Outer Dowsing Offshore Wind

Outer Dowsing Noise Abatement Systems Commitment Clarification Note

Document Reference: 27.6

Figure 4 Predicted SEL contours at 5 dB increments for a single monopile installation at the ANS Northwest location, in relation to Humber Estuary SAC

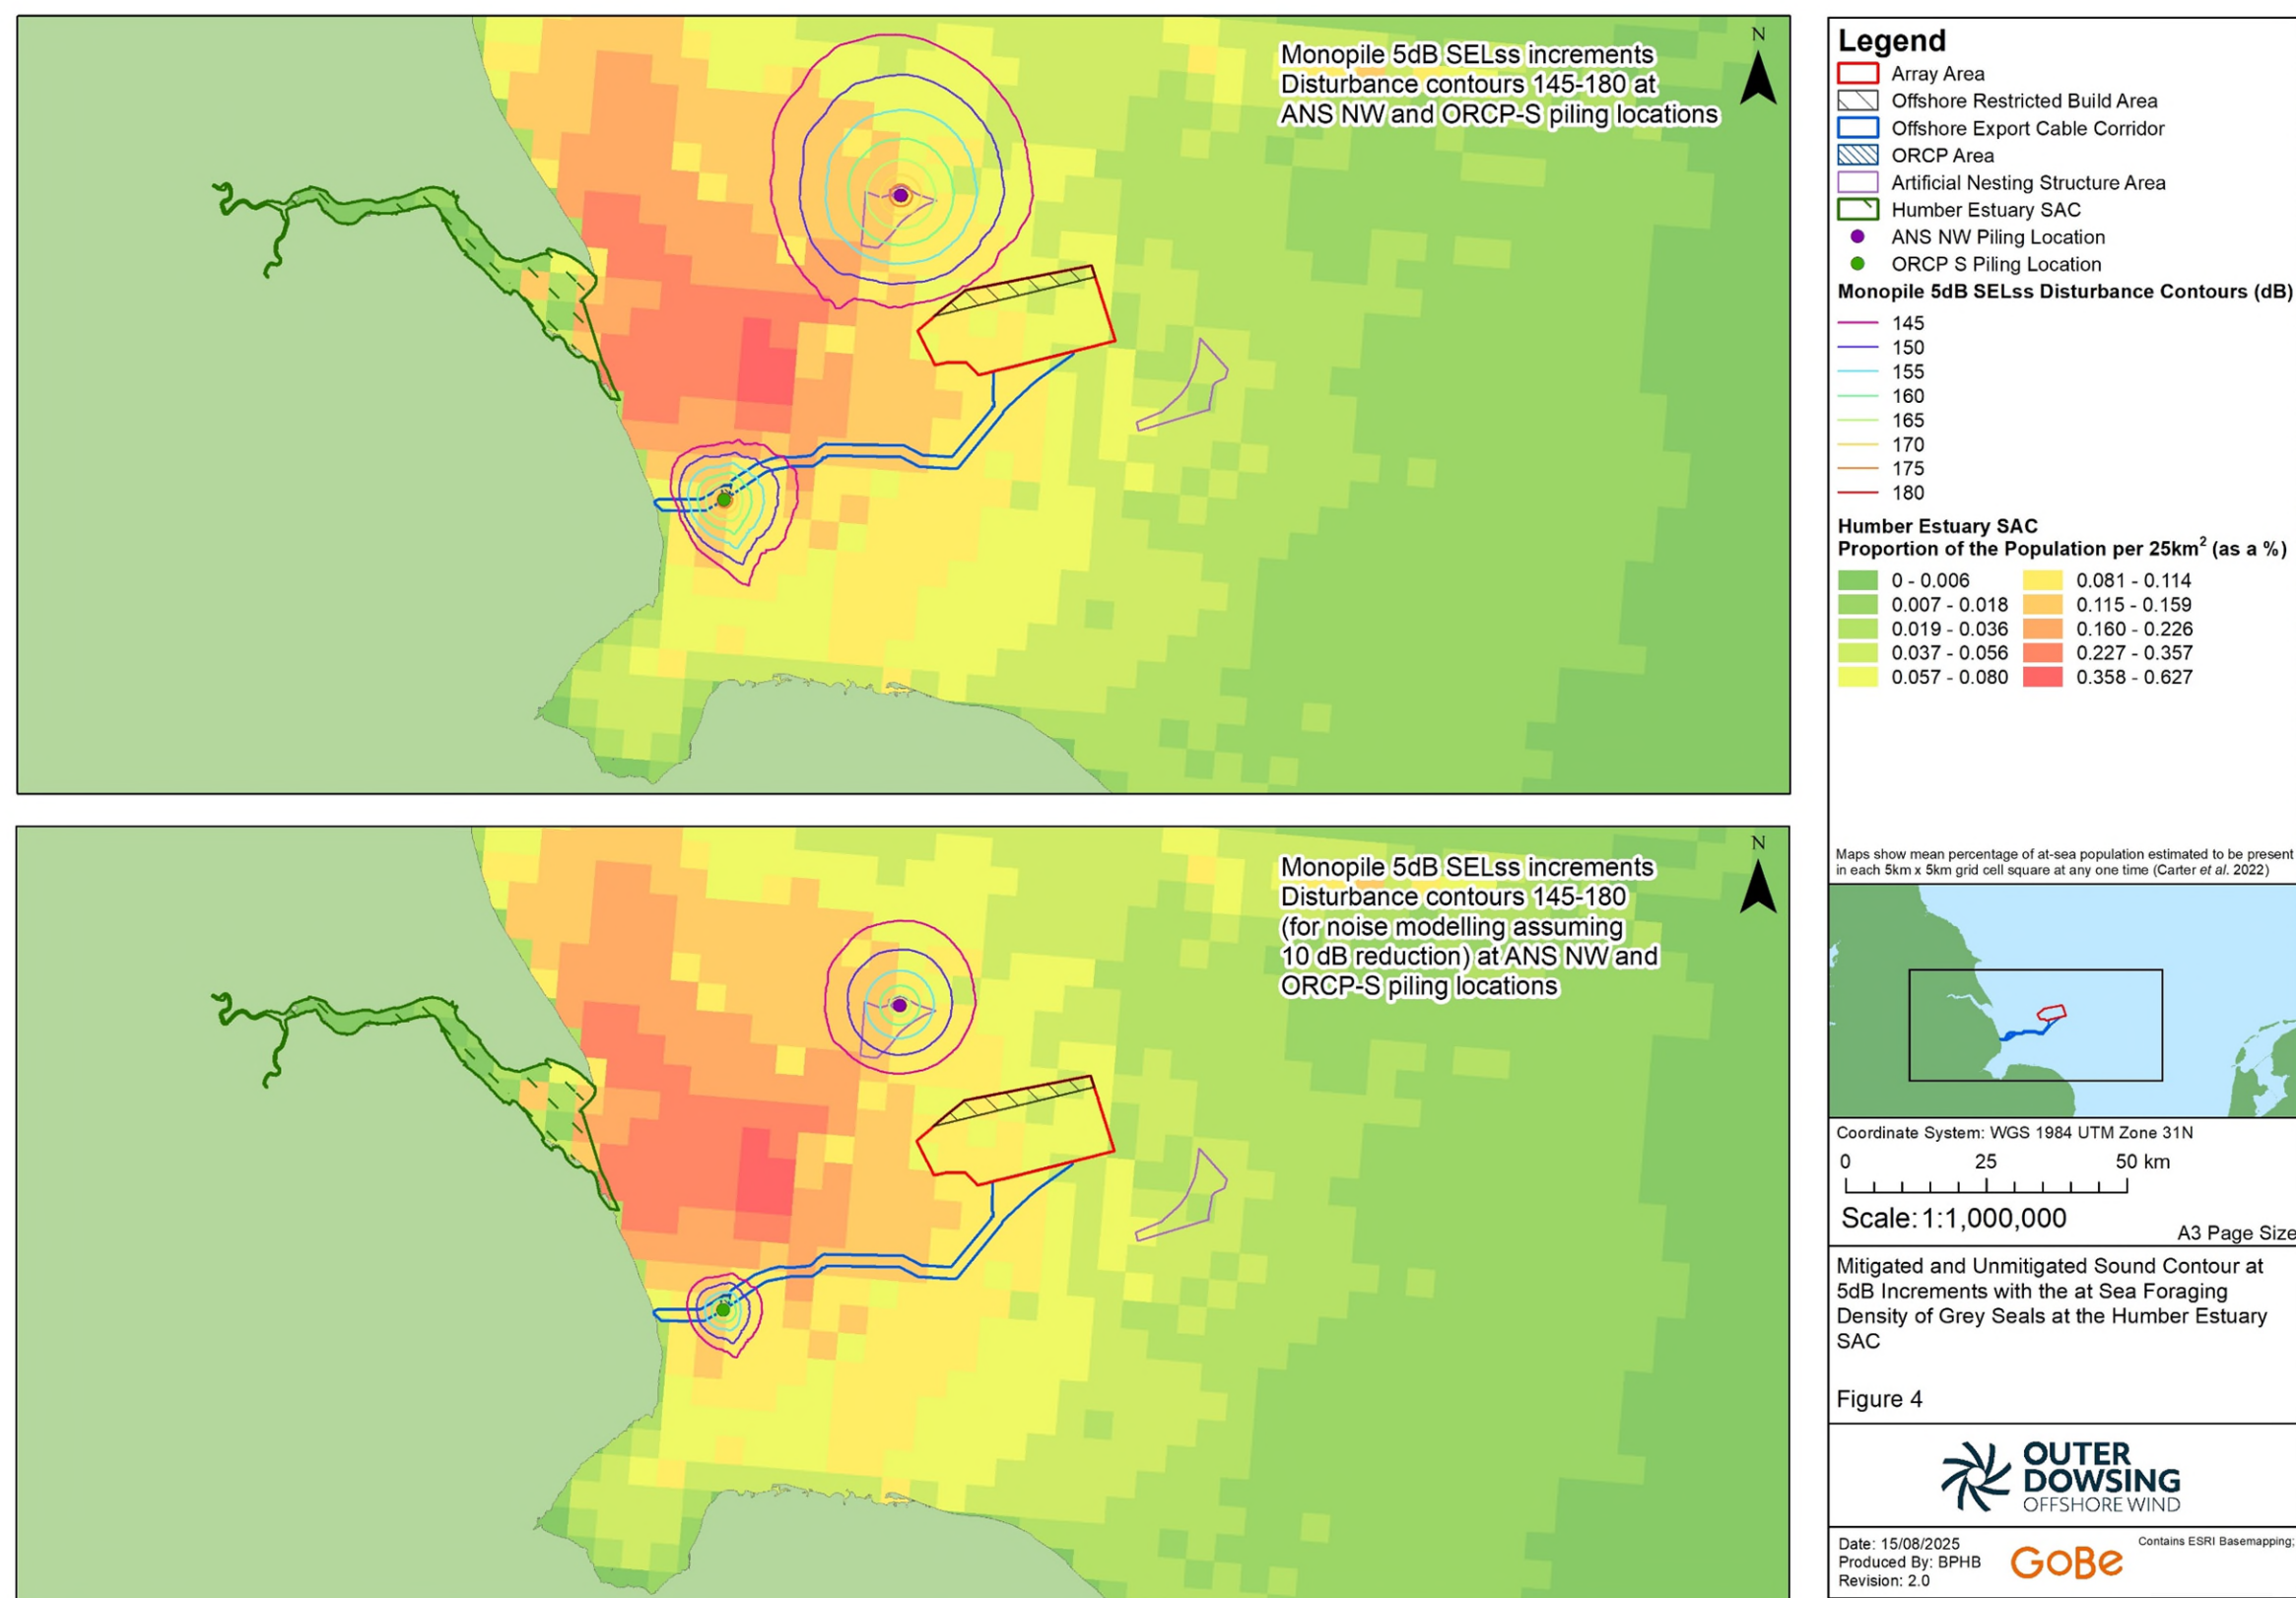
"Natural England cannot agree to the conclusion of no AEoI on grey seals because of the high proportion of animals expected to be disturbed by the project in combination with other projects from underwater noise ... To reduce the disturbance to grey seals, the Applicant should commit to noise abatement or noise reducing technology. This commitment would resolve issues associated with grey seal disturbance."

72. The Applicant maintains that an AEol on the grey seal feature of the Humber Estuary SAC can be ruled out. To support this position, Figure 4 presents the predicted SEL contours for a single monopile installation at the worst-case location ANS Northwest and also at the ORCP⁸, overlaid with grey seal at-sea density data associated with the Humber Estuary SAC (from Carter *et al.*, 2022). The ANS Northwest location is considered the worst-case location due to the number of individuals disturbed. The figure compares unmitigated and mitigated scenarios, with the latter assuming a 10 dB reduction in source levels, consistent with the Applicant's commitment to NAS. Under the unmitigated scenarios, the predicted SEL contours at both the ANS Northwest and the ORCP location cover a larger area, extend closer to the SAC boundary, and overlap with more area of higher grey seal density. In contrast, the mitigated scenarios show a reduction in the spatial extent of the SEL contours, greater distance from the SAC boundary to the outermost noise contours and overlap with less area of higher grey seal density. When the reduced disturbance contours for mitigated piling are considered in the dose-response function, up to 205 grey seals are predicted to be disturbed at the worst-case ANS Northwest location, which is a reduction when compared to the unmitigated scenario of 724 individuals presented in Table 11-70 of Chapter 11: Marine Mammals (REP6-020). When the reduced disturbance contours for mitigated piling are considered in the dose-response function, up to 52 grey seals are predicted to be disturbed at the ORCP location, which is a reduction when compared to the unmitigated scenario of 193 individuals presented in Table 11-70 of Chapter 11: Marine Mammals (REP6-020). This reduction in numbers disturbed would apply to all piling locations within the Project area as a result of reduced area of disturbance when assuming a 10 dB reduction in source levels.

74. The reduction in the predicted extent of noise exposure under the mitigated scenario highlights the benefit of NAS in reducing the disturbance impact to the grey seal feature within and outwith the SAC. The noise contours presented in Figure 4 therefore support the Applicant's position that the commitment to NAS helps to reduce the risk of disturbance and reinforces the conclusion of no AEol from the Project alone on the Humber Estuary SAC.
